This is to certify that Giroux Oil Company Inc/Biskun construct City of Portland  
has permission to Construct a pre-engineered 45' x 5' canopy for storage crew emp tanks and equipment.  
AT 8 Newcomb St / 343 Warren Ave CE 303 D001001 - 7 to 010

**RE: Giroux Oil Canopy Addition**  
**343 Warren Avenue**  
**Minor Site Plan**  
**Application ID # 09-79900025**  
**CBL: 303-D-010-001**

**Amended Minor Site Plan Application**  
**Giroux Oil Company**  
**343 Warren Avenue, Portland, Maine**  
**Response to Staff Comments**

SHEET NUMBER  
**A-1**

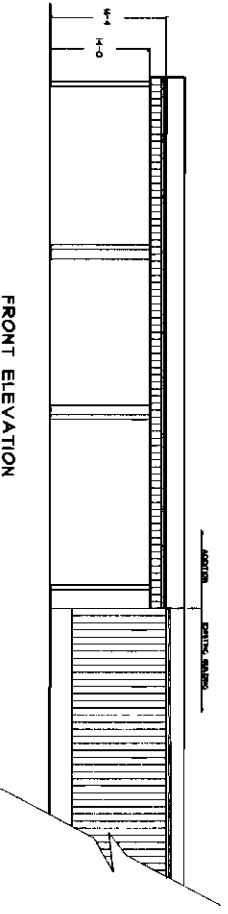
- **Provide a building elevation showing the proposed canopy in the context of the existing storage building to which it is attached.** The Floor Plan and Elevation of the proposed Canopy Expansion, as prepared by Biskup Construction Inc., is attached to this e-mail.
